RE: LFPCN41226

Subject : LFPCN41226- Commercial TVS Datasheet Characterization

PCN Report

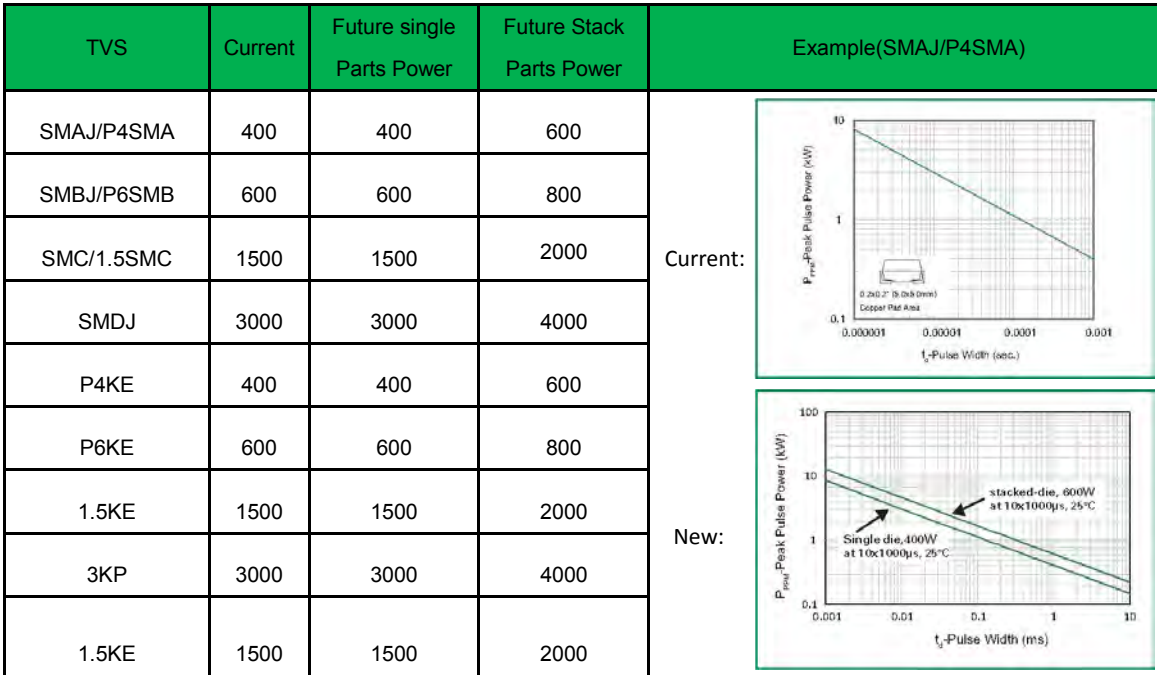
E: Update SMAJ/P4SMA series note “VF<3.5V for devices of VBR ≤ 200V and VF<6.5V for devices of VBR ≥ 201V ” to “VF < 3.5V for single dice parts and VF< 5V for stacked dice parts”
 Update the others series note “VF<3.5V for devices of VBR ≤ 200V and VF<5V for devices of VBR ≥ 201V ” to “VF < 3.5V for single dice parts and VF< 5V for stacked dice parts”

➤ Figure - Peak Pulse Power Rating Curve

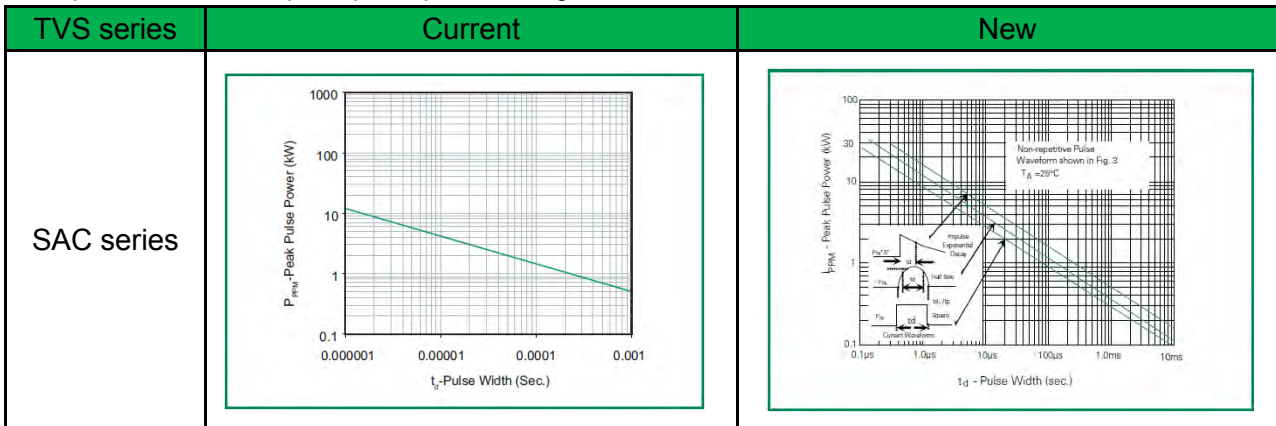
5.1 Add one curve to specify stack-die parts pulse power.

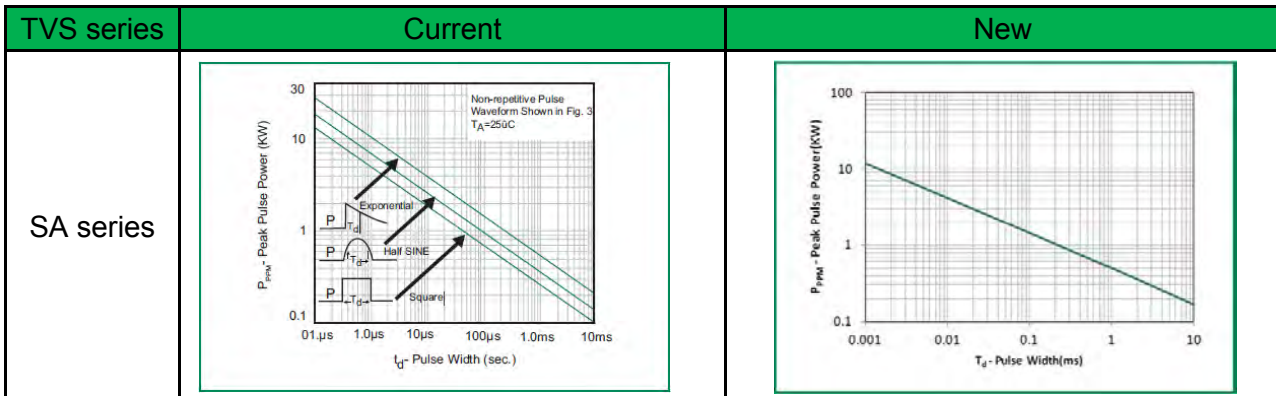
5.2 Update SAC series peak pulse power rating curve

➤ **Figure - Pulse Derating Curve**

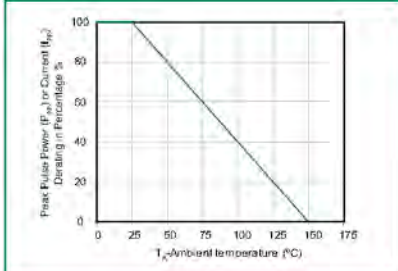
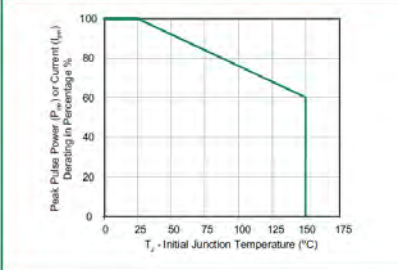
5.4 Update the derating curve.

Pulse Derating Curve			
TVS	Current Power Rating@Tjmax	New Power Rating@Tjmax	Example(SMAJ/P4SMA)
SMAJ/P4SMA	0%	60%	<div style="display: flex; flex-direction: column; align-items: center;"> <div style="margin-bottom: 20px;"> <p>Current:</p>  </div> <div> <p>New:</p>  </div> </div>
SMA6J/SMA6L	0%	40%	
SACB	0%	60%	
SMBJ/P6SMB	0%	60%	
1KSMB	0%	60%	
SMCJ/1.5SMC	0%	60%	
SMDJ	0%	50%	
3.0SMC	0%	50%	
4.0SMDJ	0%	50%	
5.0SMDJ	0%	50%	
P4KE	0%	50%	
SA	0%	50%	
SAC	0%	60%	
P6KE	0%	50%	
1.5KE	0%	50%	
LCE	0%	60%	
3KP	0%	50%	
5KP	0%	50%	
15KP	0%	50%	
20KP	0%	50%	
30KP	0%	50%

➤ **Figure - Typical Junction Capacitance**

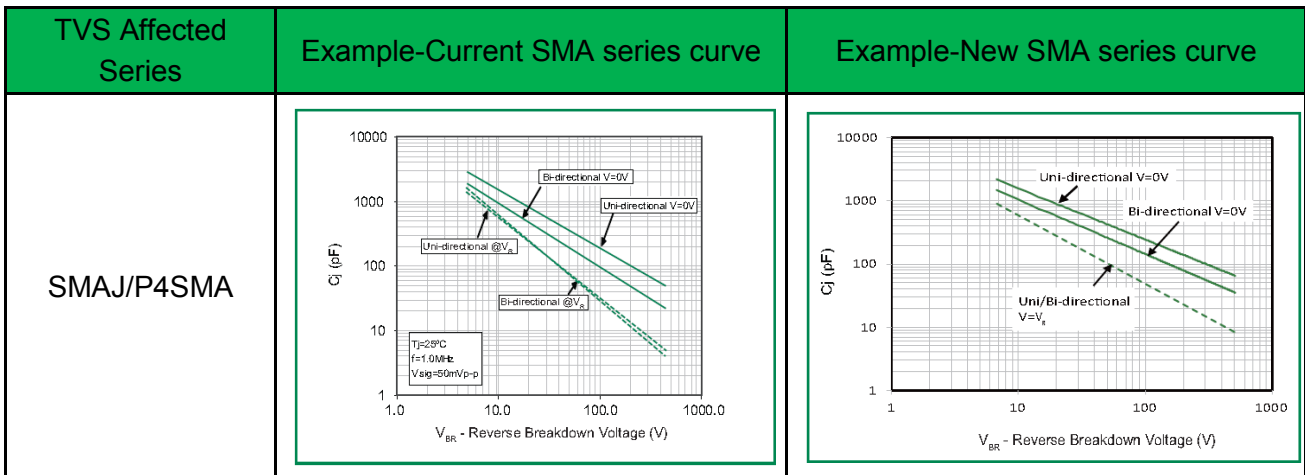
5.5 Update capacitance curve

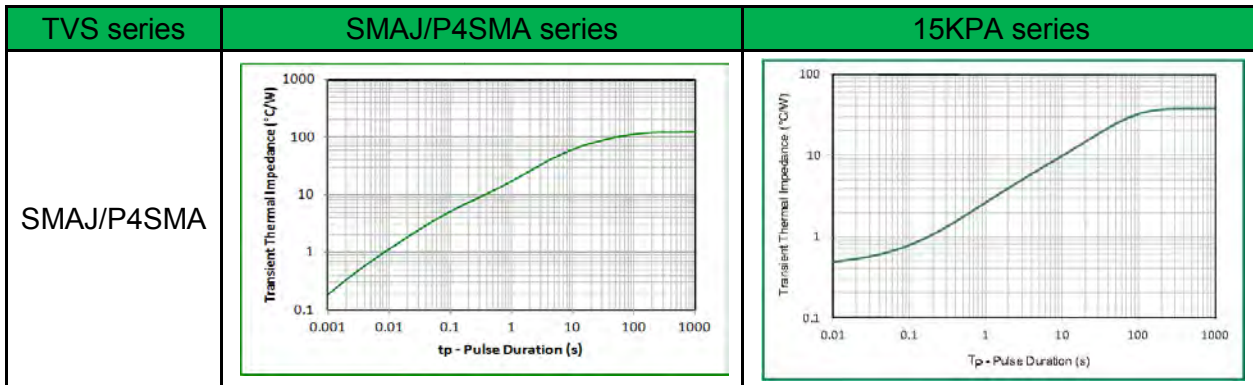
5.7 Add new figure - Typical Transient Thermal Impedance

➤ Figure - Maximum Non-Repetitive Forward Surge Current Uni-Directional Only

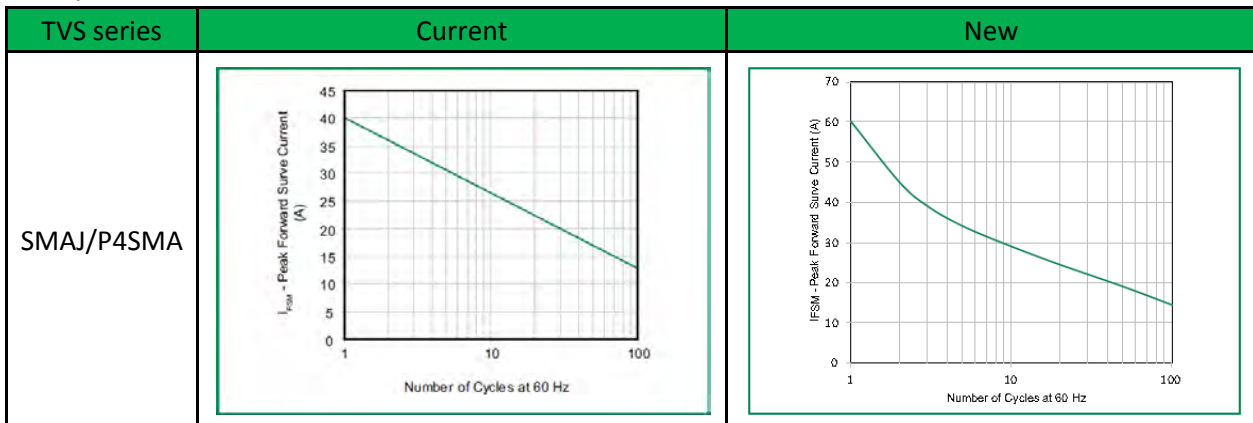
5.8 Update maximum forward surge current (uni-directional only)

➤ **Figure - Peak forward voltage drop versus peak forward current (typical values)**

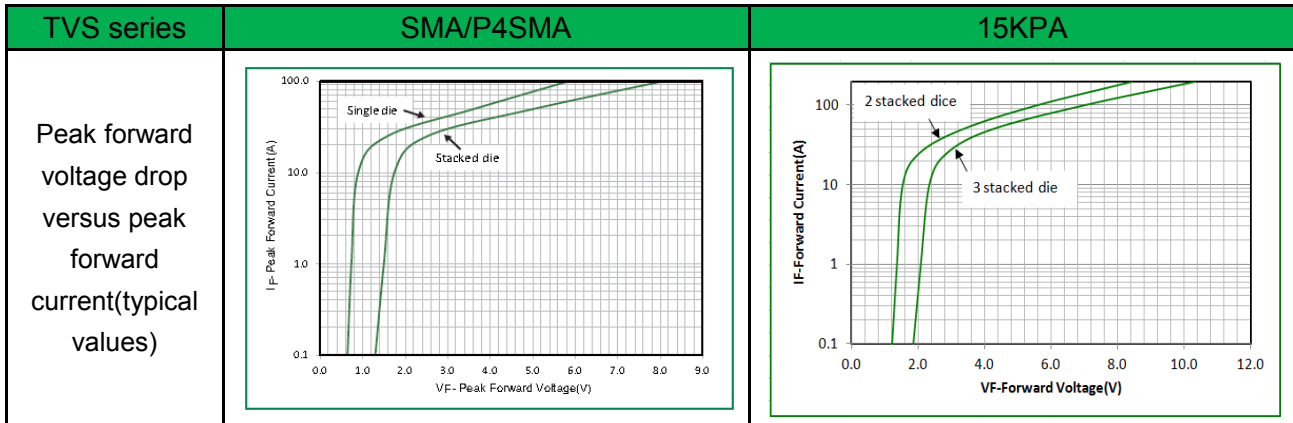
5.9 Add new figure (only apply to uni-directional TVS)
